ADDENDUM No. 1

Date: August 14, 2025 **Project No:** M25005 (05-2025)

Project Name: Request for Proposal: Town of Shelburne
Hot Mix Asphalt Surfacing of Municipal Roads, Laneways & Trail Construction 2025

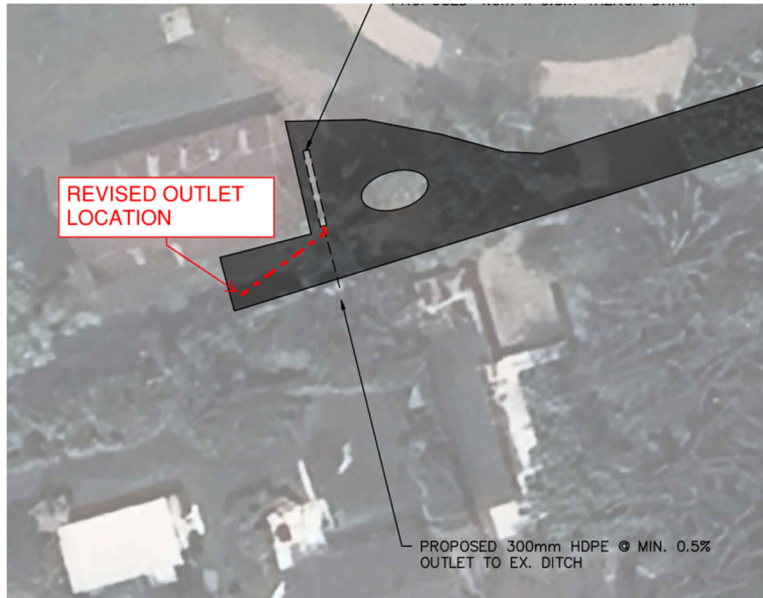
4. Bidders are to note that due to cover restraints, the outlet of the trench drain under Schedule 2 will need to be relocated approximately 12 m west (downstream). Therefore, to maintain proper alignment, bidders shall account for fittings. See sketch below.
